RE: **Lot 4 Block 4 Volcano Cliffs Unit 22 SAD 228**
6300 Petirrojo NW
Grading and Drainage Plan (D10D003F13A)
Engineers Stamp Date 2/10/20
Pad Certification Date 3/27/20

DRAINAGE AND TRANSPORTATION INFORMATION SHEET (REV 6/2018)

ENGINEER'S SEAL	6300 PETIRROJO	DRAWN BY WCVJ
DAVID SOULE NEW MEXICO REGISTERED PROFESSIONAL ENGINEER 14522	GRADING AND DRAINAGE PLAN	DATE 2-04-20
		21721-LAYOUT-3-20-17
2/10/20	 Rio Grande Engineering 1606 CENTRAL AVENUE SE SUITE 201 ALBUQUERQUE, NM 87106 (505) 872-0988	SHEET #
DAVID SOULE P.E. #14522		JOB # 21721

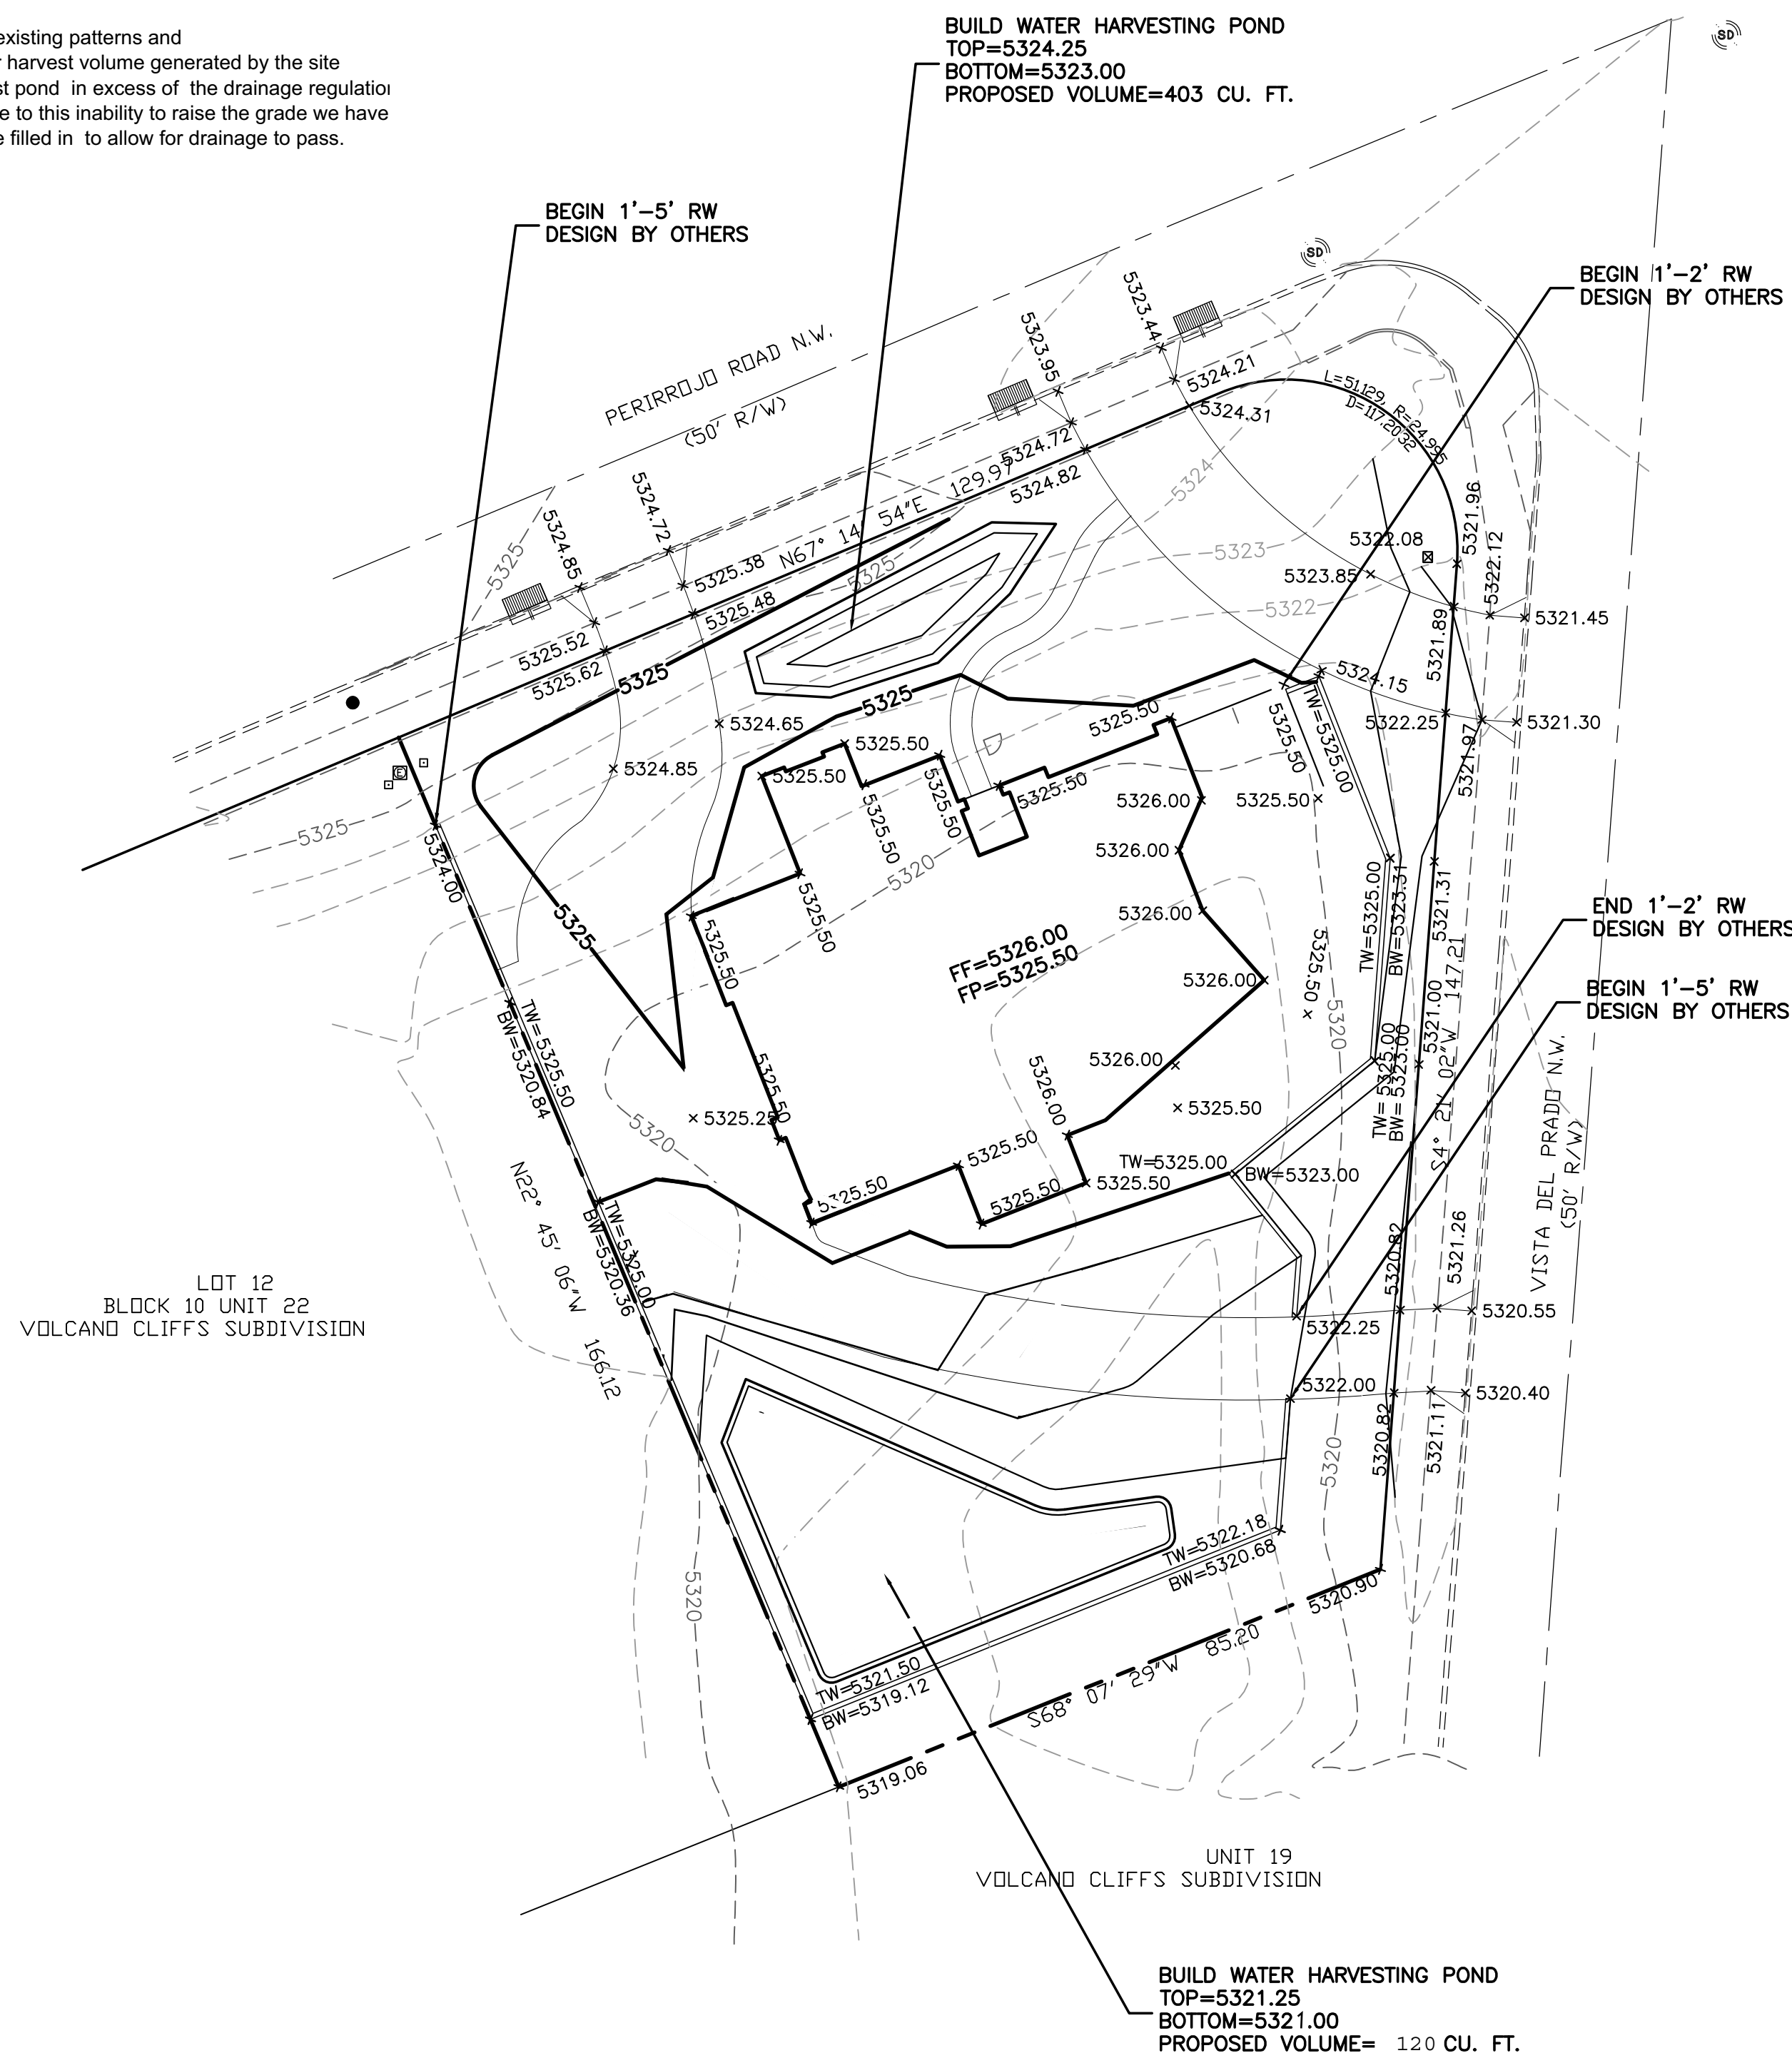
Based upon the information provided in your submittal received 3/20/20, this plan is approved for Building Permit.

Reiterate to the Owner/Contractor that a separate permit for a garden/retaining wall must be obtained, with the approved G&D plan dated 3/26/20 and Pad Certification Date 3/26/20.

Prior to Certificate of Occupancy release, Engineer Certification per the DPM checklist of this plan will be required.
